City of Boise ADA
Assessment

Appendix A - Warm Springs Golf Course

Report #TO21-B019

ID: 1492 **Facility:** Warm Springs Golf Course

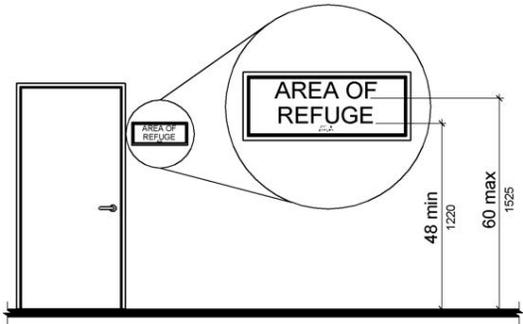
2010 ADA Standards for Accessible Design Codes §216.2, §703
There is no tactile sign identifying the permanent room.

Install tactile signage on the latch side of the doorway at a height of 48” minimum to 60” maximum above the floor, identifying room by name or room number.

ID: 1493 **Facility:** Warm Springs Golf Course

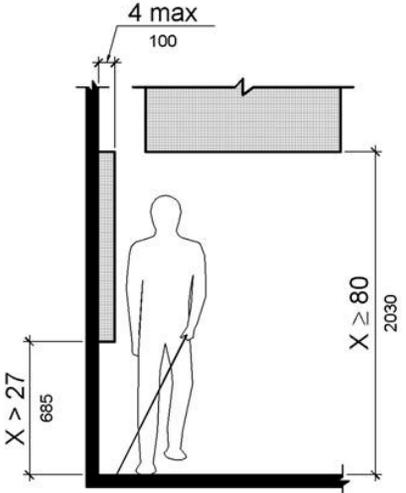
2010 ADA Standards for Accessible Design Codes §307.2
The TV protrudes 6.75" into the circulation space at 55" above the floor.

Recess the TV so it protrudes a maximum of 4", raise it so the bottom edge is 80" maximum above the floor, or place a cane detectable object beneath it.

ID: 5
Facility: Warm Springs Golf Course

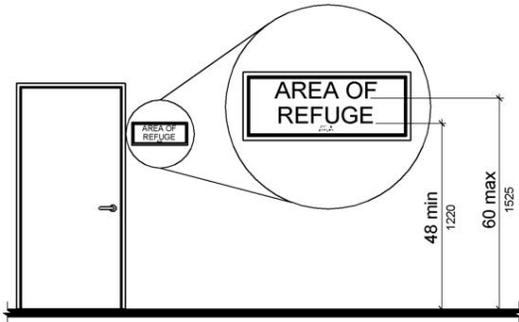
2010 ADA Standards for Accessible Design Codes §216.2, §703
 There is no tactile sign identifying the permanent room.

Install tactile signage on the latch side of the doorway at a height of 48” minimum to 60” maximum above the floor, identifying room by name or room number.
 Signs shall be Braille with raised lettering and should be placed on the wall in the center of an 18"x18" clear floor space.

ID: 1471 **Facility:** Warm Springs Golf Course

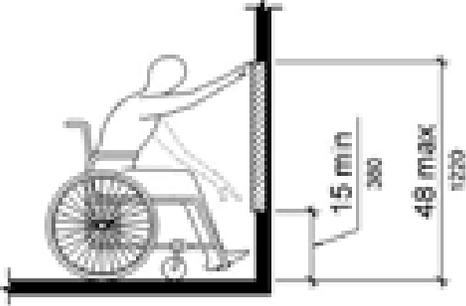
2010 ADA Standards for Accessible Design Codes §308.2.1
The hand sanitizer is outside of the unobstructed forward reach range at 55" above the floor.

Lower the hand sanitizer by 7" to meet the accessible reach range of 48" maximum above the floor.

ID: 4485 **Facility:** Warm Springs Golf Course

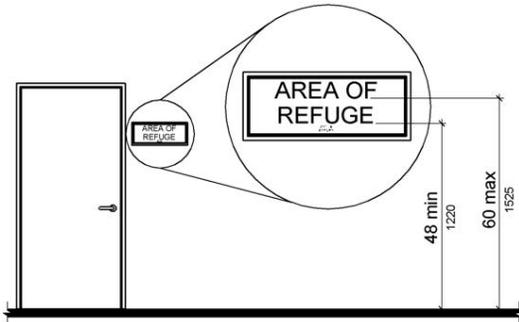
2010 ADA Standards for Accessible Design Codes §216.2, §703
There is no tactile sign identifying the permanent room.

Install tactile signage on the latch side of the doorway at a height of 48" minimum to 60" maximum above the floor, identifying room by name or room number.
Signs shall be Braille with raised lettering and should be placed on the wall in the center of an 18"x18" clear floor space

ID: 1509 **Facility:** Warm Springs Golf Course

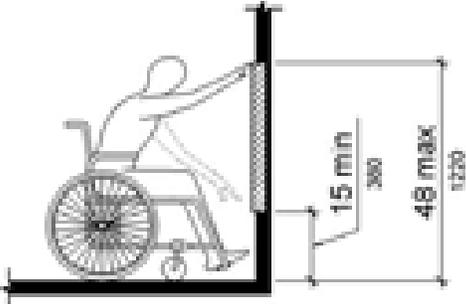
2010 ADA Standards for Accessible Design Codes §308.2.1
The paper towel dispensers are outside of the unobstructed forward reach range at 55" above the floor.

Lower the paper towel dispensers by 7" to meet the accessible reach range of 48" maximum above the floor.

ID: 1503 **Facility:** Warm Springs Golf Course

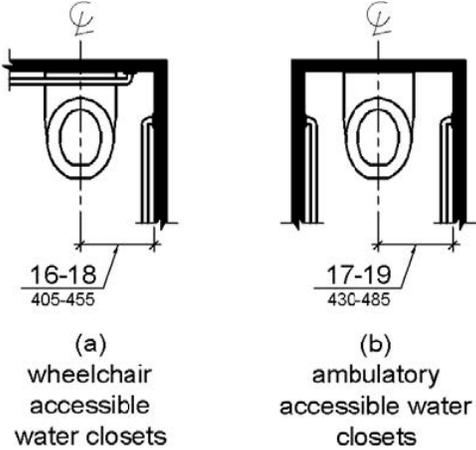
2010 ADA Standards for Accessible Design Codes §604.2
The centerline of the toilet is located 20.5" from the sidewall.

Reposition the centerline of the toilet to be within 16" minimum and 18" maximum from the sidewall.

ID: 1506 **Facility:** Warm Springs Golf Course

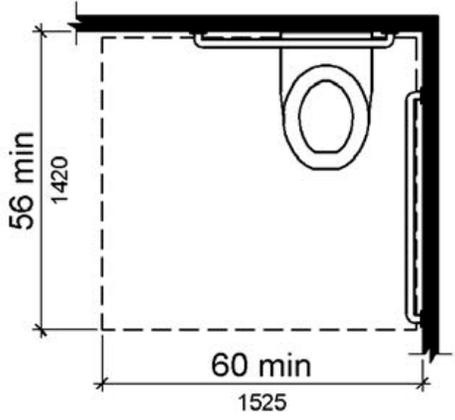
2010 ADA Standards for Accessible Design Codes §604.3.1, §213.3.1, §604.8.1.1, §604.5.1
The sided grab bars are located 8.5" and 7" from the rear wall and are 31" long.
There is not a wheelchair accessible stall in this restroom. The stall is too narrow at 42.5" wide.

Replace the side grab bar with one that is a minimum of 42" long minimum, located 12" maximum from the rear wall, and extending 54" from the rear wall.
Expand the restroom to ensure 60" minimum measured perpendicular from the side wall and 56" minimum measured perpendicular from the rear wall.

ID: 1483 **Facility:** Warm Springs Golf Course

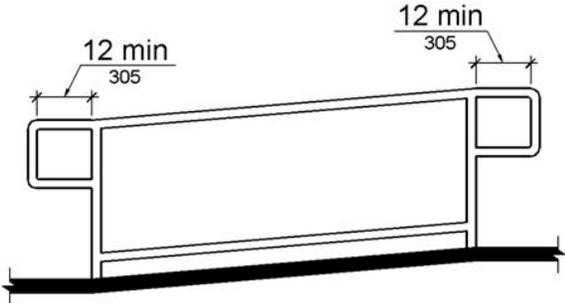
2010 ADA Standards for Accessible Design Codes §505.10
There are no handrail extensions for the ramp.

Extend the ramp handrails 12" horizontally beyond the top and bottom of ramp runs.

ID: 1484 **Facility:** Warm Springs Golf Course

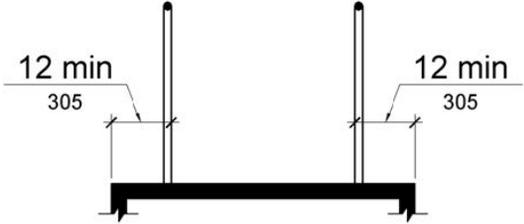
2010 ADA Standards for Accessible Design Codes §405.9, §505.2
There is no handrail on the left side of the ramp. There is no edge protection on either side of the ramp.

Install a handrail at a minimum height of 34" and maximum of 38" above the ground. Make sure there are adequate handrail extensions both at the top and bottom of the handrail.

Install edge protection on either side of the ramp by extending the floor surface an additional 12" beyond the inside face of the handrails or by installing new handrails that have a lower barrier to prevent the passage of a 4" diameter sphere.

ID: 1487 **Facility:** Warm Springs Golf Course

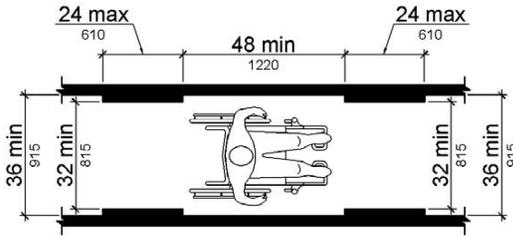
2010 ADA Standards for Accessible Design Codes §403.5.1
The path in the back of the pro shop is 28.5" wide.

Widen the path to allow for a minimum clear width of 36". This can be achieved by reorganizing the displays and relocating one of the golf club displays.

ID: 1488 **Facility:** Warm Springs Golf Course

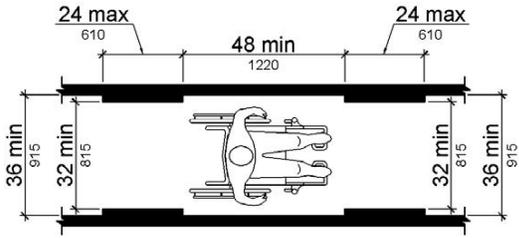
2010 ADA Standards for Accessible Design Codes §403.5.1
Due to the table, the circulation path is reduced to 22.5" wide.

Remove the table to widen the route to 36".

ID: 1490 **Facility:** Warm Springs Golf Course

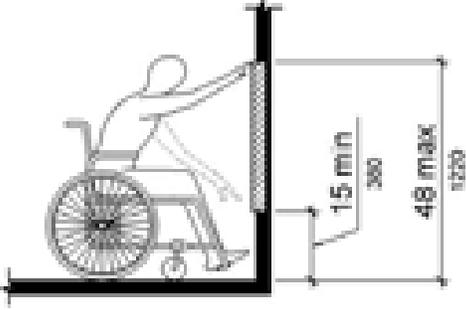
2010 ADA Standards for Accessible Design Codes §308.2.1
The hook is outside of the unobstructed forward reach range at 63" above the floor.

Lower the hook by 15" to meet the accessible reach range of 48" maximum above the floor.

ID: 1497 **Facility:** Warm Springs Golf Course

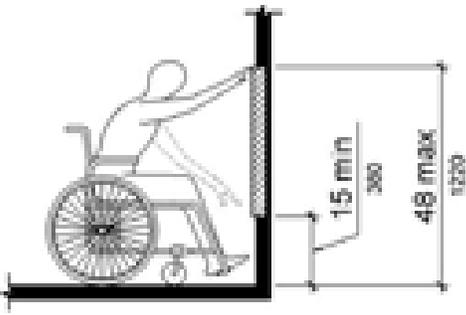
2010 ADA Standards for Accessible Design Codes §308.2.1
The paper towel dispenser is outside of the unobstructed forward reach range at 55" above the floor.

Lower the paper towel dispenser by 7" to meet the accessible reach range of 48" maximum above the floor.

ID: 4486 **Facility:** Warm Springs Golf Course

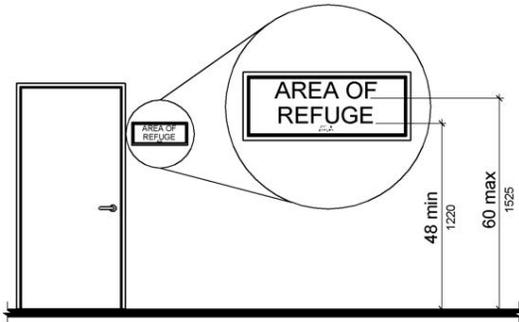
2010 ADA Standards for Accessible Design Codes §216.2, §703
There is no tactile sign identifying the permanent room.

Install tactile signage on the latch side of the doorway at a height of 48” minimum to 60” maximum above the floor, identifying room by name or room number.
Signs shall be Braille with raised lettering and should be placed on the wall in the center of an 18"x18" clear floor space.

ID: 1495 **Facility:** Warm Springs Golf Course

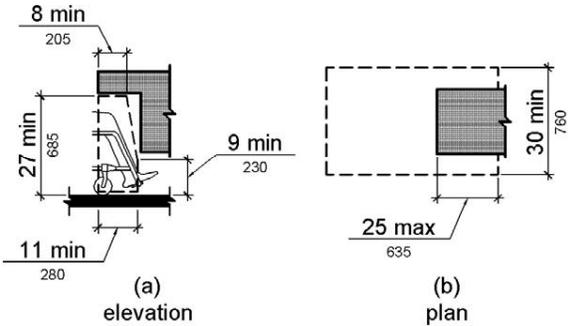
2010 ADA Standards for Accessible Design Codes §606.3, §306.3.3
There is no knee clearance underneath the sink. The sink is 35.25" above the floor.

Provide knee clearance underneath the counter at the sink that is a minimum of 11" deep at 9" above the floor and 8" deep at 27" above the floor.
Lower the sink to a maximum height of 34" above the floor.

ID: 1491 **Facility:** Warm Springs Golf Course

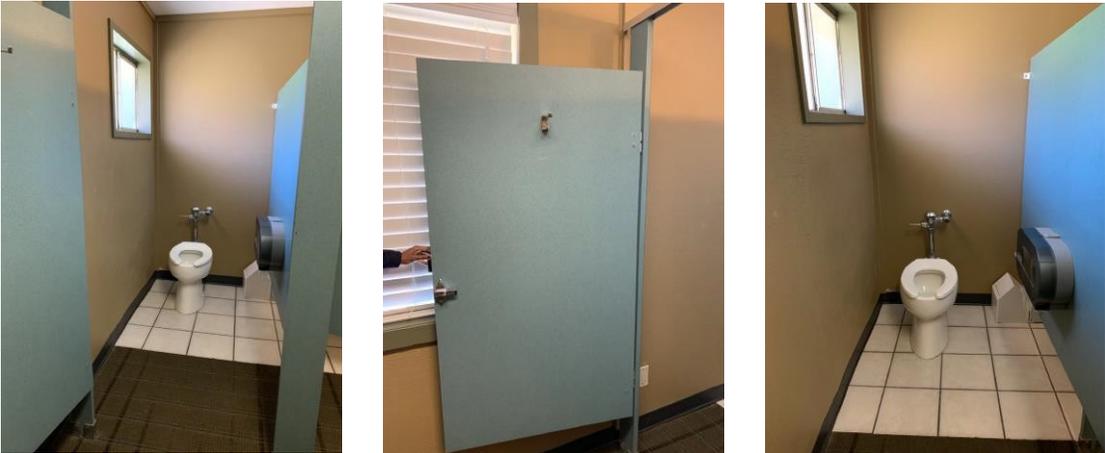
The flush control is located on the wall side of the toilet. The toilet compartment size is too small at 43" wide and 76.5" long.

There are no grab bars.

Either make the toilet flush automatically or relocate the flush control to be operated on the open side of the toilet. Expand the non-accessible stall to be one 60" wide wheelchair accessible toilet stall, complying with §604.8.

Install a side and rear grab bar at a minimum height of 33" and maximum height of 36" above the floor. The side grab bar shall have a minimum length of 42". The side grab bar shall be a maximum of 12" from the back wall.

ID: 1517 **Facility:** Warm Springs Golf Course

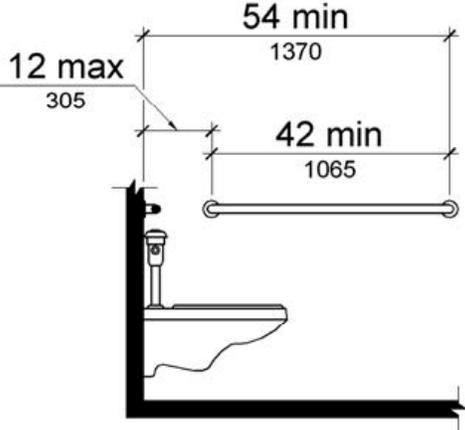
2010 ADA Standards for Accessible Design Codes §604.5.1
The side grab bar is 53" long.

Replace the side grab bar with one that is a minimum of 42" long minimum, located 12" maximum from the rear wall and extending 54" minimum from the rear wall.

ID: 1522 **Facility:** Warm Springs Golf Course

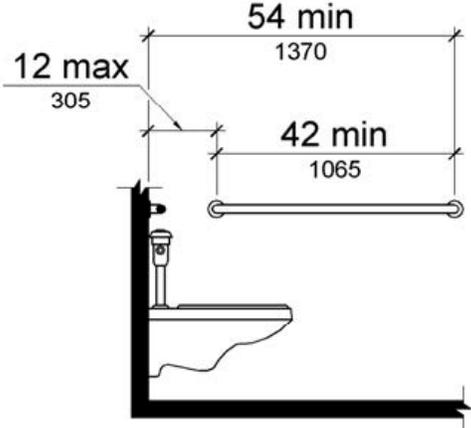
2010 ADA Standards for Accessible Design Codes §604.5.1
The side grab bar is 52" long.

Replace the side grab bar with one that is a minimum of 42" long minimum, located 12" maximum from the rear wall and extending 54" minimum from the rear wall.

ID: 1530 **Facility:** Warm Springs Golf Course

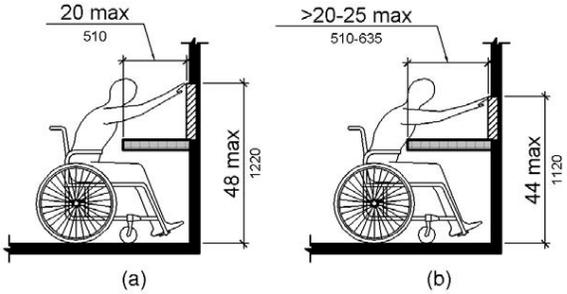
2010 ADA Standards for Accessible Design Codes §308.2.2
The microwave is outside of the obstructed forward reach range at 64" above the floor.

If requested, lower the microwave to the counter.

ID: 1526 **Facility:** Warm Springs Golf Course

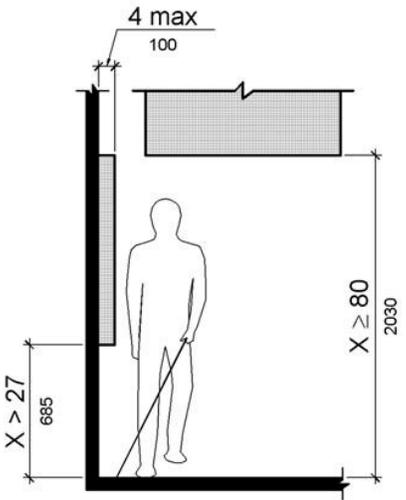
2010 ADA Standards for Accessible Design Codes §307.2, §308.2.1
The hand sanitizer is outside of the unobstructed forward reach range at 64" above the floor.
The hand sanitizer protrudes 7" into the circulation space at 67" above the floor.

Lower the hand sanitizer by 16" to meet the accessible reach range of 48" maximum above the floor.
Recess the hand sanitizer so it protrudes a maximum of 4" or place a cane detectable object beneath it.

ID: 1529 **Facility:** Warm Springs Golf Course

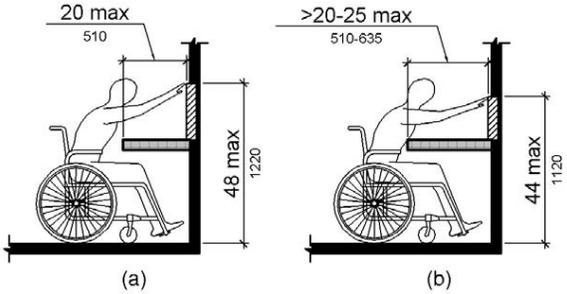
2010 ADA Standards for Accessible Design Codes §308.2.2
The paper towel dispenser is outside of the obstructed forward reach range at 50" above the floor.

Lower the paper towel dispenser by 2" to meet the accessible reach range of 48" maximum above the floor.

ID: 1531 **Facility:** Warm Springs Golf Course

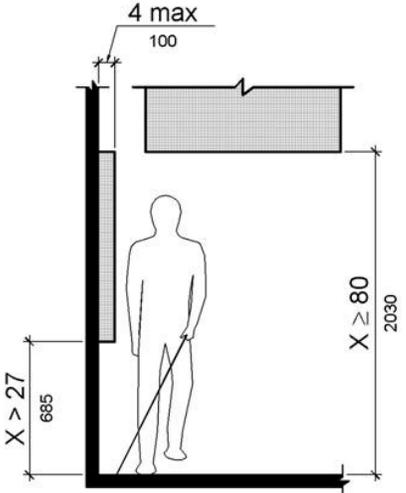
2010 ADA Standards for Accessible Design Codes §307.2
The TV protrudes 4.5" into the circulation space at 71" above the floor.

Recess the TV so it protrudes a maximum of 4", raise it so the bottom edge is 80" maximum above the floor, or place a cane detectable object beneath it.

ID: 1532 **Facility:** Warm Springs Golf Course

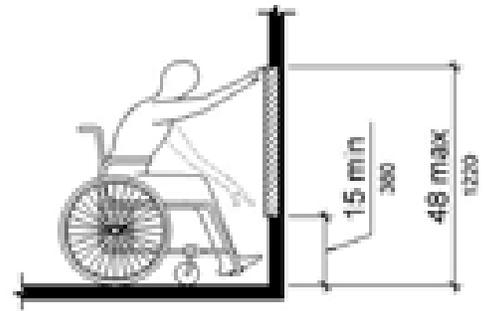
The hooks are outside of the unobstructed forward reach range at 73" above the floor.

Ensure 5% of the hooks are lowered to be a maximum of 48" above the floor.

ID: 1533 **Facility:** Warm Springs Golf Course

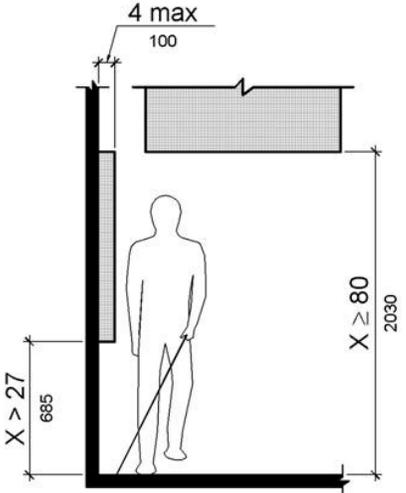
2010 ADA Standards for Accessible Design Codes §307.2
The paper towel dispenser protrudes 7.5" into the circulation space at 48" above the floor.

Remove the protruding paper towel dispenser.
Remove the pallet and cardboard box from underneath the paper towel dispenser to provide a 30"x48" clear floor space.

ID: 1544 **Facility:** Warm Springs Golf Course

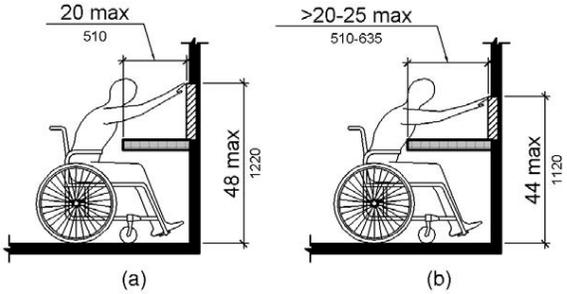
2010 ADA Standards for Accessible Design Codes §308.2.1
The hand sanitizer is outside of the unobstructed forward reach range at 59" above the floor.

Lower the hand sanitizer by 11" to meet the accessible reach range of 48" maximum above the floor.

ID: 1527 **Facility:** Warm Springs Golf Course

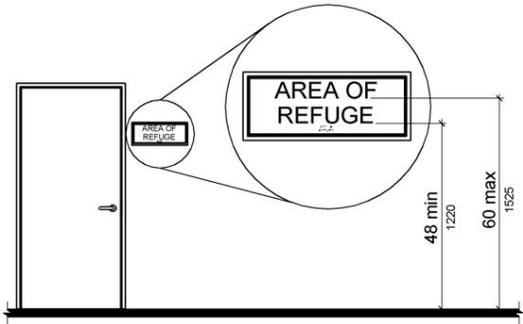
2010 ADA Standards for Accessible Design Codes §216.4, §703
Doors serving as exits are not marked by tactile signage.

Place a tactile exit sign, that complies with §703.1, §703.2 and §703.5, identifying the exit doors.
Install missing signage at 48" minimum above the floor measured from the baseline of the lowest character and 60" maximum measured from the baseline of the highest character.

ID: 1540 **Facility:** Warm Springs Golf Course

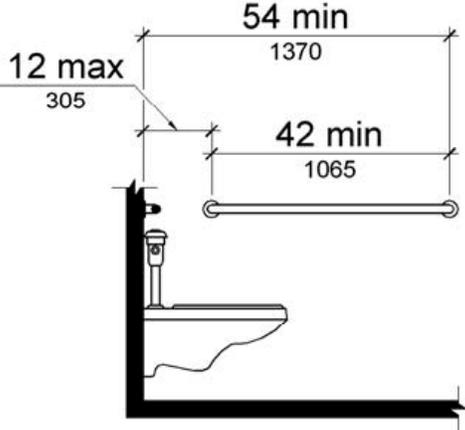
2010 ADA Standards for Accessible Design Codes §604.5.1
The side grab bar is located 6.5" from the rear wall.

Remount the side grab bar 12" maximum from the rear wall and extending 54" minimum from the rear wall.

ID: 1548 **Facility:** Warm Springs Golf Course

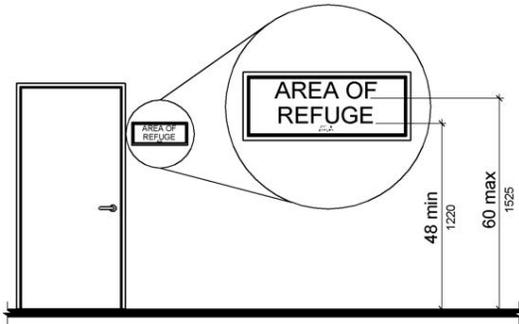
2010 ADA Standards for Accessible Design Codes §216.2, §703
There are no tactile signs identifying six permanent room.

Install tactile signage on the latch side of the doorway at a height of 48” minimum to 60” maximum above the floor, identifying room by name or room number.
Signs shall be Braille with raised lettering and should be placed on the wall in the center of an 18"x18" clear floor space.

ID: 1535 **Facility:** Warm Springs Golf Course

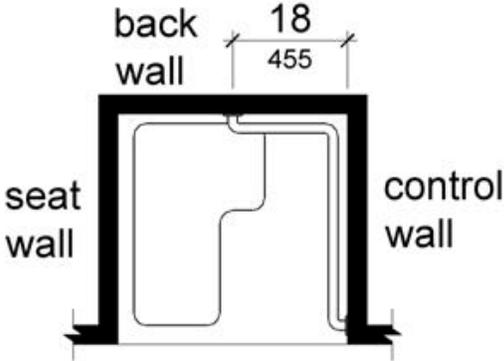
2010 ADA Standards for Accessible Design Codes §608.3, §609
The back wall grab bar is 16.5" long.

Install a back wall grab bar to a point 18" from the control wall at a maximum height of 36" above the bathroom floor.

ID: 1477 **Facility:** Warm Springs Golf Course

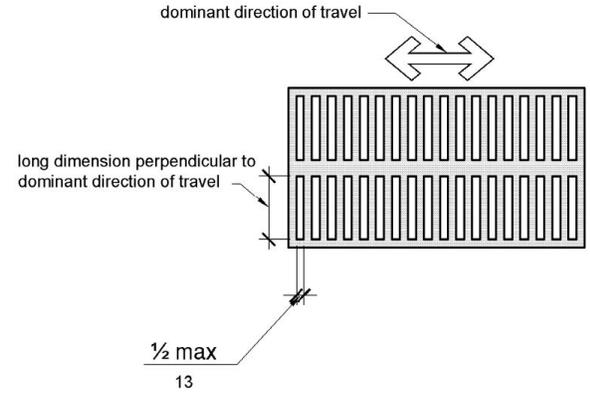
2010 ADA Standards for Accessible Design Codes §302.3
There is a 2.5" gap in the accessible route posing a tripping hazard.

Fill in the gap to ensure that it is a maximum of 0.5" wide.

ID: 1481 **Facility:** Warm Springs Golf Course

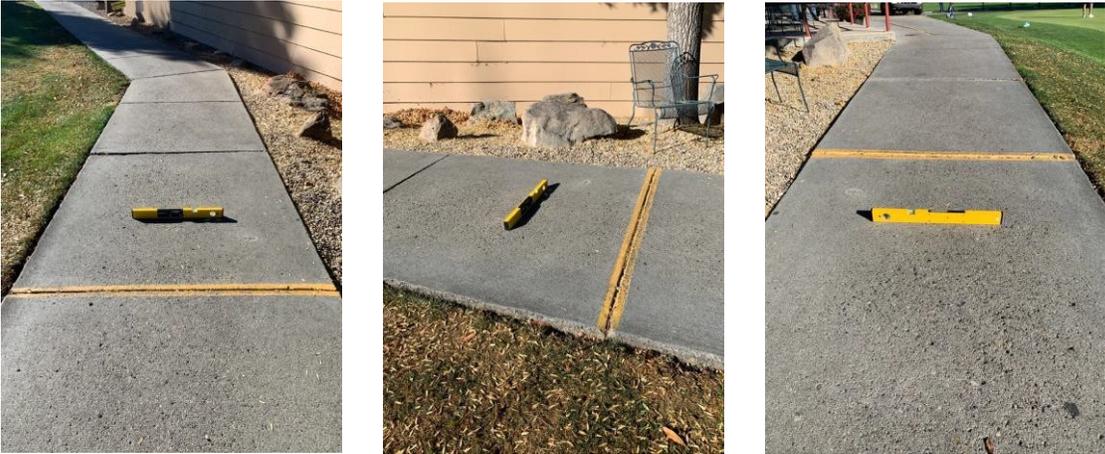
2010 ADA Standards for Accessible Design Codes §303.2
There is a 0.75" change in level.

Resurface the pathway to reduce the change in level to 0.5" if beveled.
